5TH & LENORA

DRB#1 - SUMMARY

New Street Trees
- DRB#1 SITE PLAN
- 
- DRB#2 REVISED SITE PLAN
- 
- 16
- 5TH & LENORA | PROJECT #3026266  
RECOMMENDATION MEETING #2 07.10.2018
-

# TOWER PLACEMENT

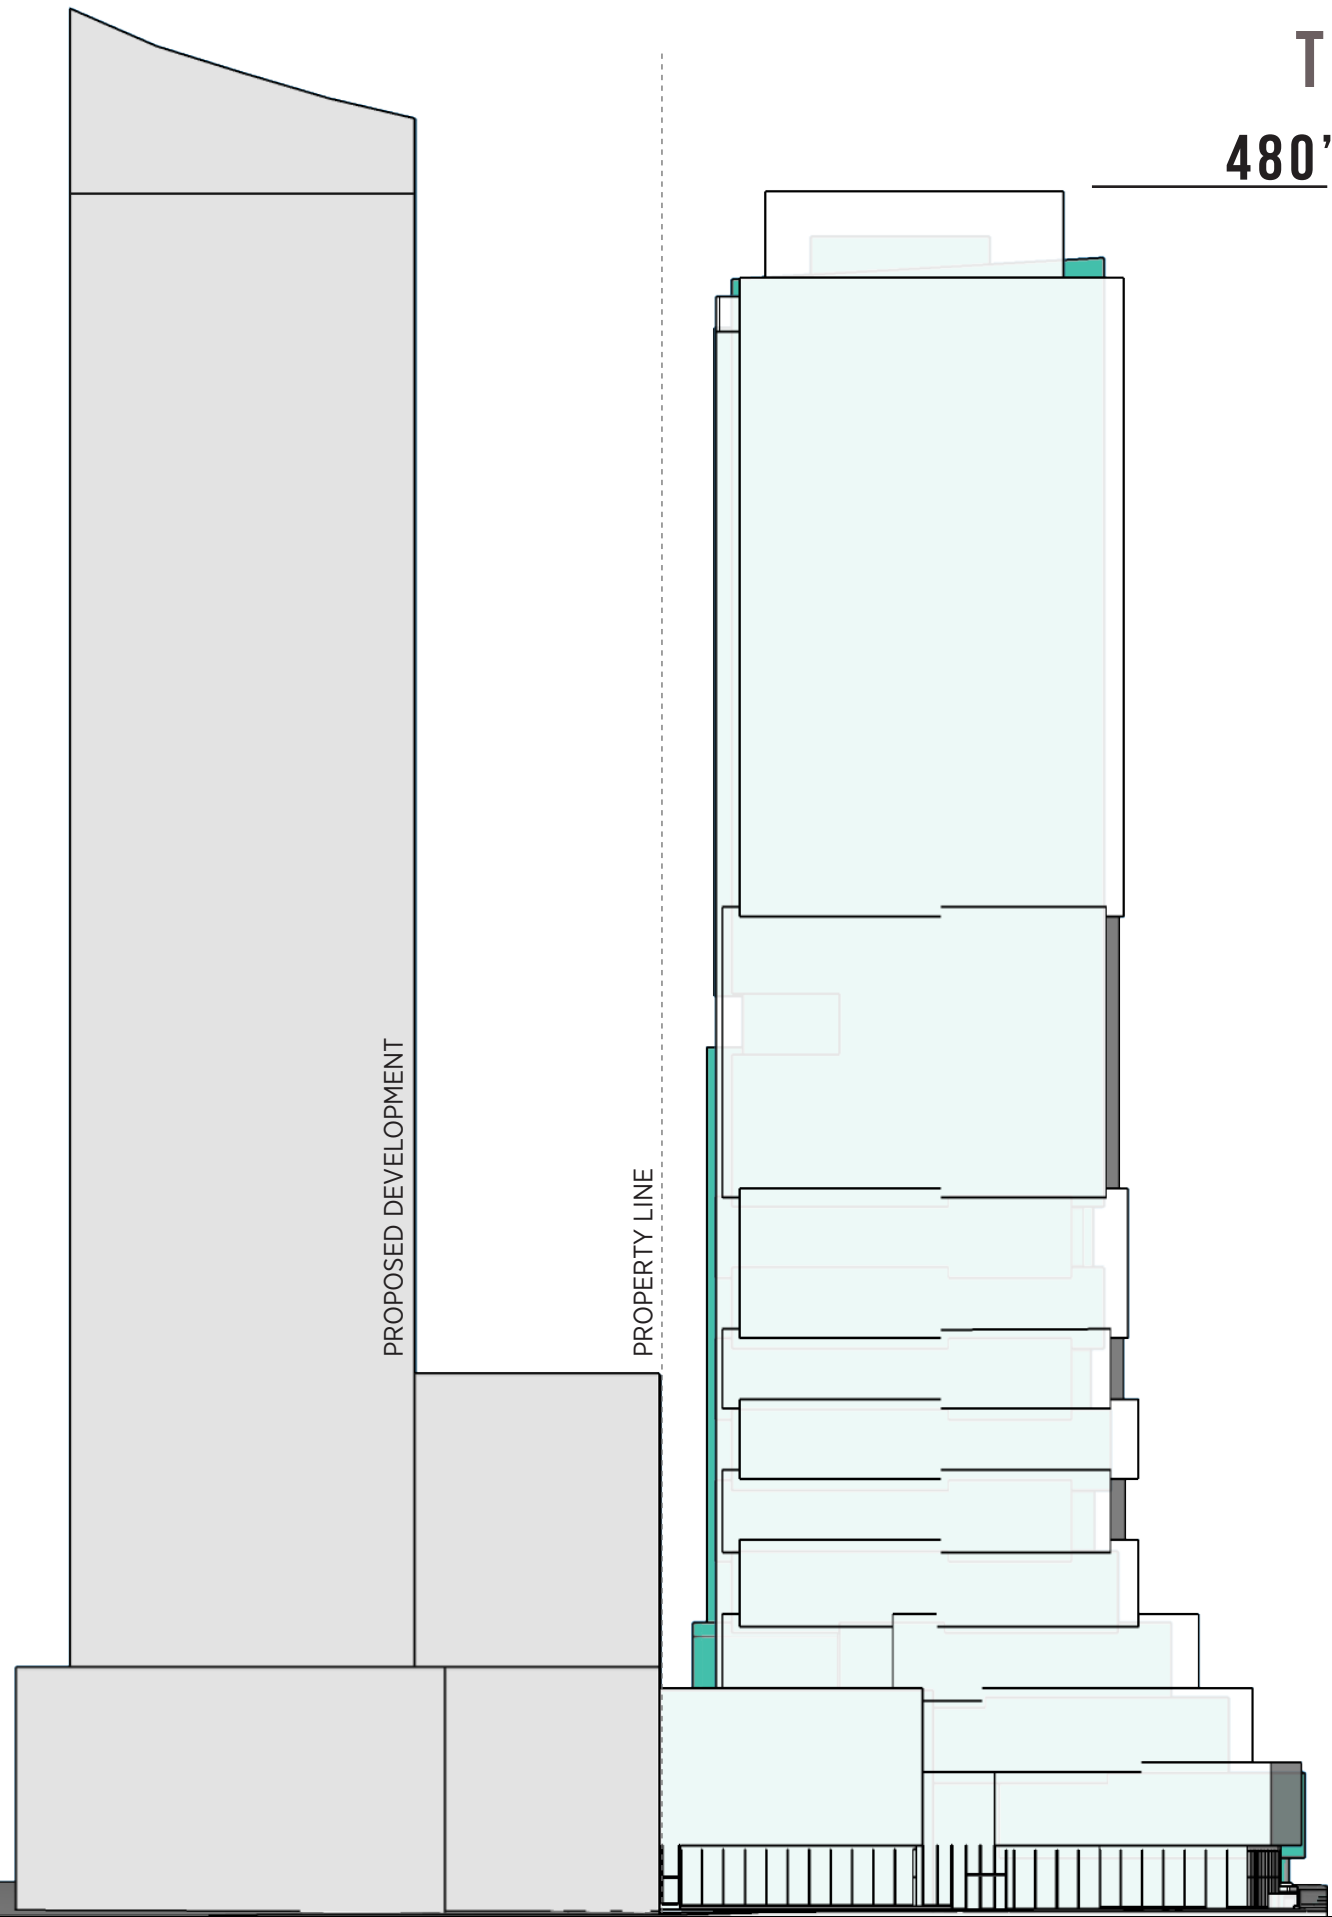
a. The board specified that if the tower moves further north, the first tray at levels 4-5 should not move north should not move north or compress and solar access to the corner of 5th and Lenora should not be preserved.

As noted in our Recommendation Meeting on April 3, 2018, we have moved the main tower mass north by approximately four feet (levaing a seperation of 16') from our EDG submittal. Daylight analysis suggests that moving the tower any further north will start to significantly impact natural light access at the corner streetscape of 5th Avenue and Lenora Street.

ROOF SCREEN PERFORATION

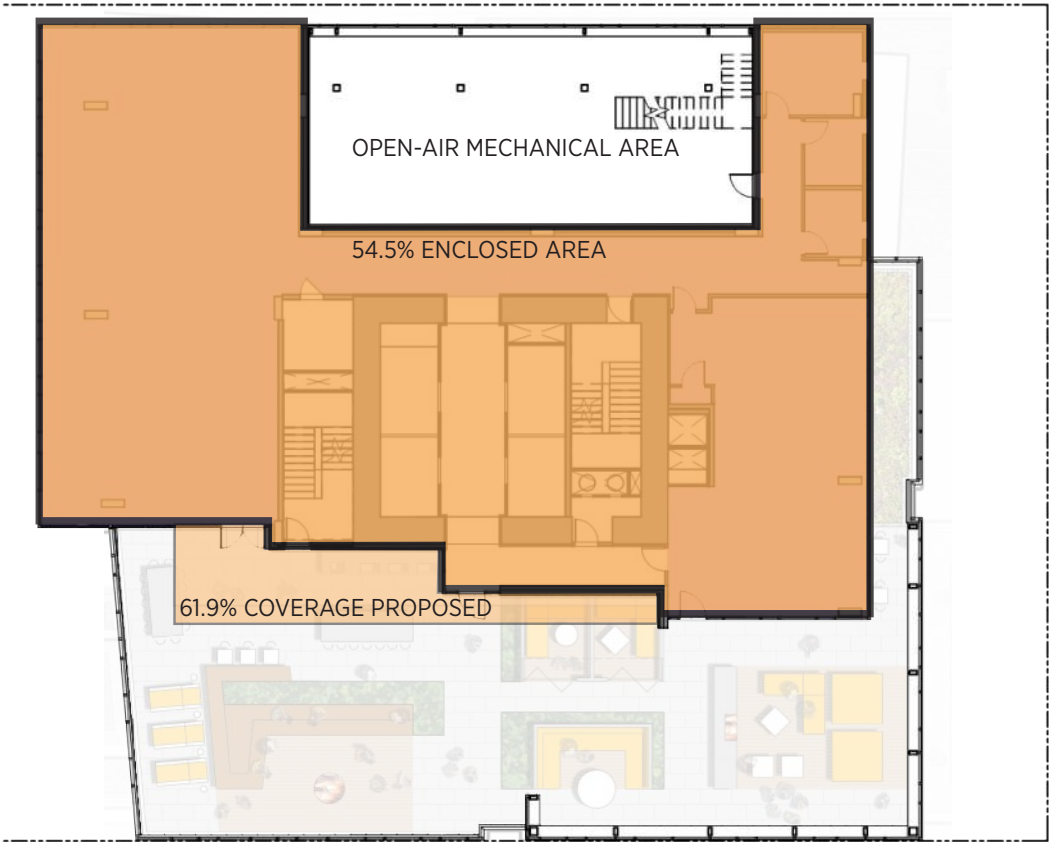
C. Members unanimously supporting Roof Option One which is the mechanical screen profile that steps back from the primary façade and they requested a scrim or screen material with some transparency be used for the mechanical screen cladding rather than the proposed louver material. (B1.III)

Roof Option One has been retained as part of our tower massing study options for this submittal. Included in this response is a design proposal for using perforated metal screens with an ornamental pattern for the mechanical screen in lieu of the metallic louvers originally proposed.

OPTION 1 - ART FOCUS

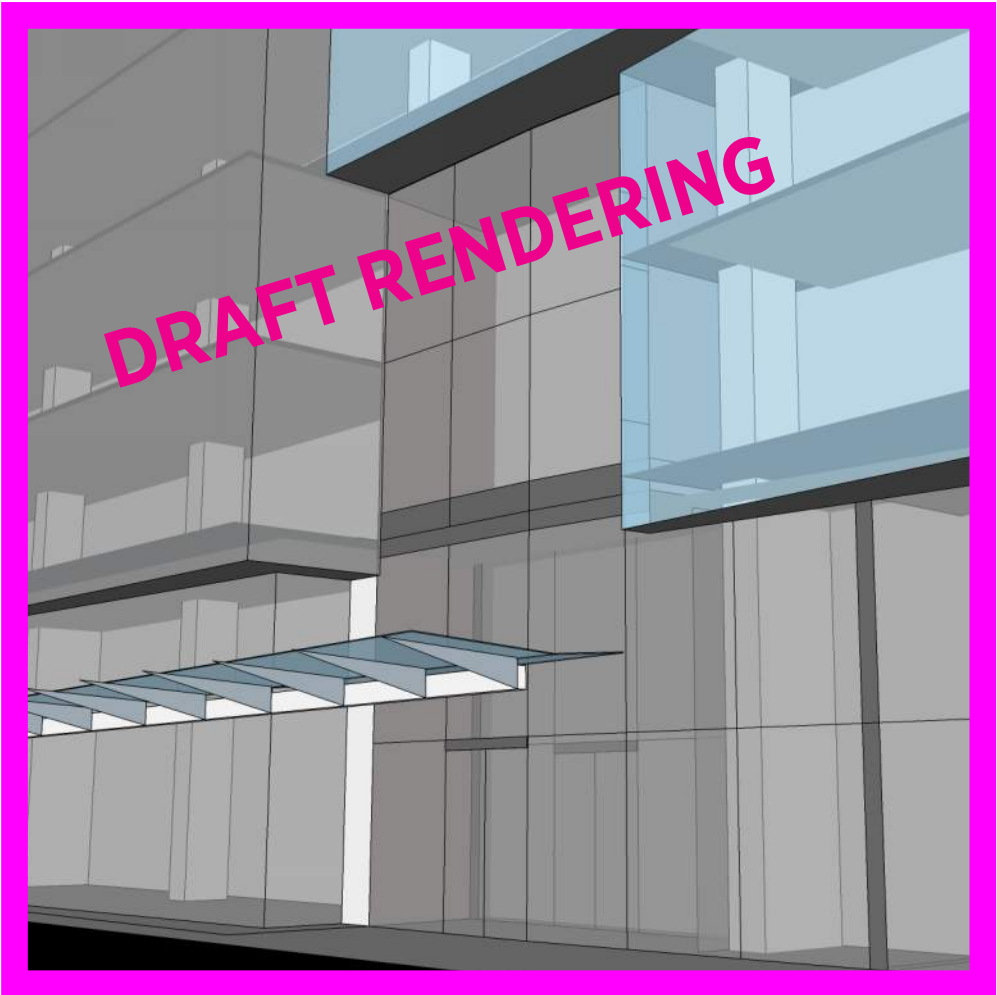
A. The Board directed the applicant to provide overhead weather protection on 5th Avenue to provide comfort for pedestrians, residents, and visitors. They mentioned the distracting nature of the undersized entry canopy and added that the overhead weather protection could help solve the issue. (B3.3)

We have provided two alternate design approaches for overhead weather protection and the entry canopy along 5th Avenue. Option 1 retains the original design as previously presented, with a small-scale entrance canopy as a secondary element to the multi-story art-glass entrance wall. We have provided further visualization of the design intent for the art glass wall to illustrate its visual impact at the streetscape. Previous presentation renderings did not show this feature since the specific art has not yet been chosen. Option 2 includes an extended canopy that provides weather protection along the sidewalk fronting on the building lobby.

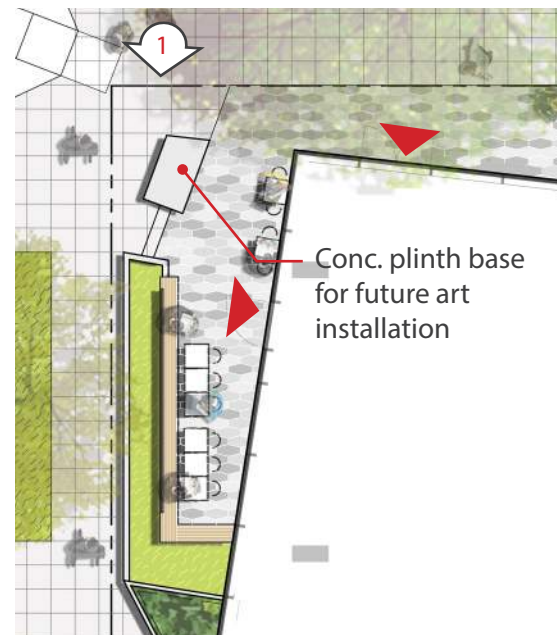
B. The Board supported the update to the Lenora Street outdoor retail seating configuration and directed the applicant to make the sidewalk facing walls of the bioretention planters appropriate width and height for seating. (B.3.3)

We have adjusted the planter wall heights and sizes to be more appropriate for seating.

The plan on the right shows the revised planter walls that integrate seating. The middle cell of each bioretention cluster has been widened to 12" to accommodate seating for the public, while still maintaining the required retention area. The middle cells also allow for the wall to be an appropriate height for seating.

## PLINTH DIAGRAM

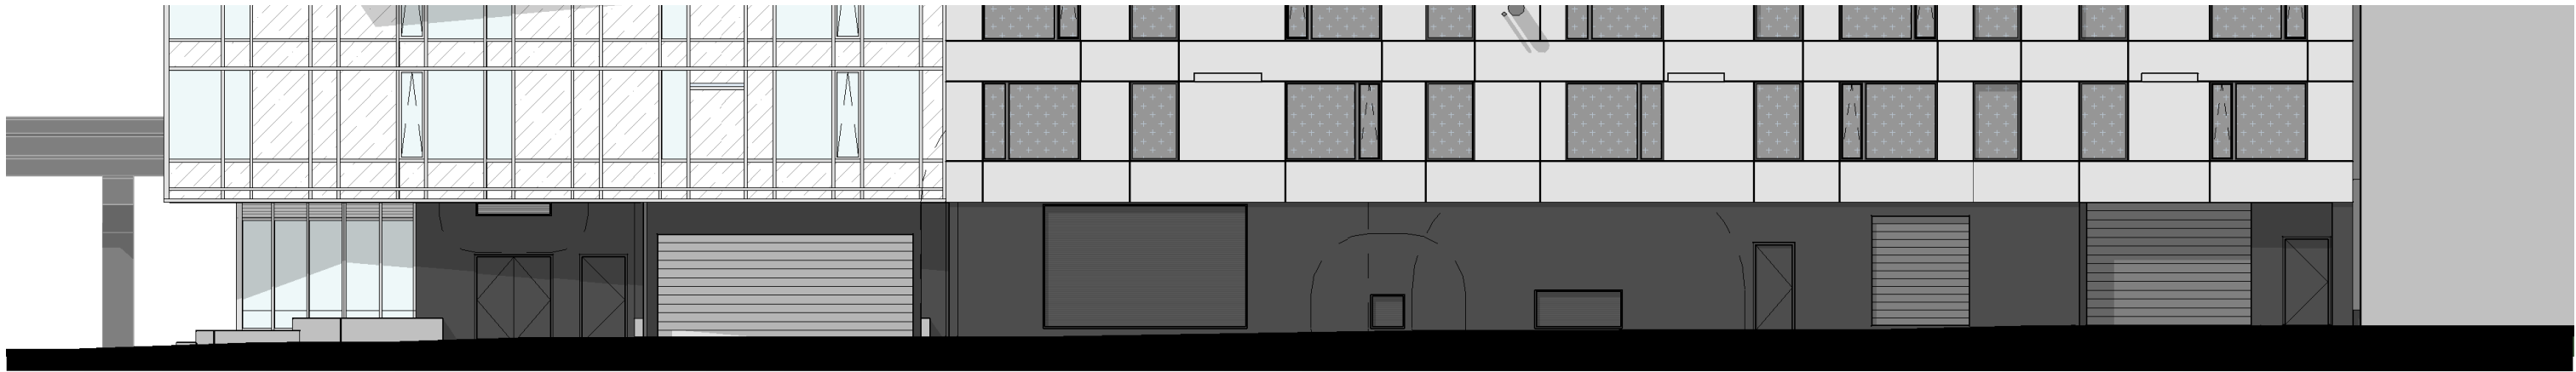
C. The board directed the applicant to develop the south plinth to incorporate either seating, texture and/or art. (B3.3, B4.3)

The design team proposes to use the concrete plinth at the corner of 5th and Lenora as a base for public art. This will enliven and activate this corner, and create a welcoming icon for this streetscape. Vulcan has installed many pieces of art in its public spaces around Seattle, and commissions sculptures that are unique and customized to fit the spaces they will reside in. Below are several representative examples of public art commission by Vulcan in the South Lake Union area.
